UNITED STATES PATENT AND TRADEMARK OFFICE

Office Action Summary

10/519,906

DETAILED ACTION

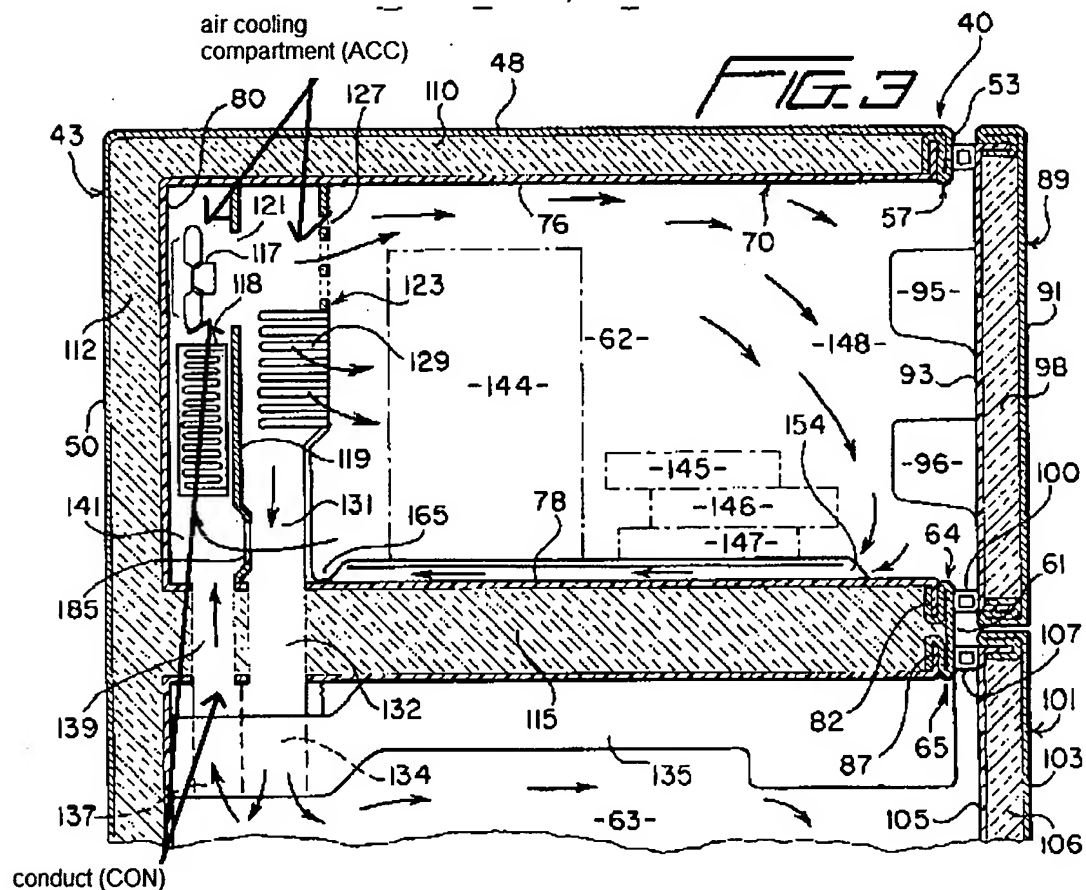
In regard to claim 1, Mandel et. al. teach an air distribution system (col 3 lines 26-28) for combined refrigerators (40) of the types which comprises a freezing compartment (62) (col 3 lines 66-67 and see Fig. 3) and a refrigerating compartment (63) (col 4 lines 3-4 and see Fig. 3), an air-cooling compartment (ACC, see annotated Fig. 3 below) lodging at least one evaporator (118) (see Fig. 3 and col 4 lines 22-23), a distributing duct (131) having a rear window (127) (col 4 lines 42-44) opened to the air-cooling compartment ((ACC, see annotated Fig. 3 below), at least one front opening (89) communicating with the freezing compartment (62) (col 3 lines 64-67). The front opening (89) allows a user to enter the freezing compartment (62) for maintenance or regular usage and the term “communicating” is interpreted to mean that the front opening (89) entrance leads to the location of the cool air contained in the freezing compartment (62).

Mandel et. al. also teach one end (139) opening maintained in communication with the refrigerating compartment (63) (see Fig. 3), and at least one fan (117) producing a forced airflow from the air-cooling compartment (ACC, see annotated Fig. 3 below) to the freezing compartment (62) and to the refrigerating compartment (63) (see Fig. 3 and col 4 lines 23-26), characterized in that the distributing duct (131) carries a conduct (CON, see annotated Fig. 3 below) having a first end (side further from fan 117) coupled to the end opening of the distributing duct (131) (see Fig. 3) and a second end (side closest to fan 117) selectively placed in fluid communication with one of the parts (121) defined by the distributing duct (131) and by the air-cooling compartment (ACC, see annotated Fig. 3 below) (col 4 lines 29-34 and see Fig. 3), said conduct being internal to the distributing duct (131) (see Fig. 3).

In regard to claim 2, Mandel et. al. teach the air distribution system characterized in that the conduct (CON, see annotated Fig. 3 below) is incorporated to the distributing duct (131) (see Fig. 3). It is interpreted that the term "incorporated" means the distributing duct (131) and conduct (CON) are placed side by side in the same air-cooling compartment (ACC).

In regard to claim 3, Mandel et. al. teach the air distribution system characterized in that the distributing duct (131) comprises a rear basic portion (78) (see Fig. 2 and col 5 lines 36-39) in the form of a vertically

disposed tray (154) having a rear wall (50) provided with a rear window (185) (see Fig. 3 and col 5 lines 55-56) and defining at least part of a front wall (61) of the air-cooling compartment (ACC, see annotated Fig. 3 below) and a front cover portion (64, 65) to be seated and affixed against the rear basic portion (78) and being provided with at least one front opening (101) (see Fig. 3 and col 3 lines 42-44).

In regard to claim 4, Mandel et. al. teach the air distribution system characterized in that the front cover portion (89) defines a wall portion of the conduct (CON, see annotated Fig. 3 below) when assembled (see Fig. 3).

In regard to claim 5, Mandel et. al. teach the air distribution system characterized in that the conduct (CON, see annotated Fig. 3 below) is maintained in selective fluid communication with one of the parts (118) defined by the distributing duct (131) and by the air-cooling compartment (ACC, see annotated Fig. 3 below) by means of respective front opening (89, 101) and rear opening (134) produced by the rupture of corresponding wall portions of the conduct (CON) (see annotated Fig. 3 below).

In regard to claim 6, Mandel et. al. teach the air distribution system characterized in that the conduct (CON, see annotated Fig. 3 below) conducts a forced airflow supplied through the inlet (132) opening coming from the distributing duct (131) to whose rear window (127) is operatively associated a fan (117) (see Fig. 3 and col 4 lines 54-56).

In regard to claim 7, Mandel et. al. teach the air distribution system characterized in that the conduct (CON, see annotated Fig. 3 below) conducts a forced airflow which is produced by a fan (117) that is operatively associated to the end opening (132) and to the refrigerating compartment (63) and which is supplied by the air-cooling compartment (ACC, see annotated Fig. 3 below) to the conduct through the rear opening (134) (see Fig. 3).
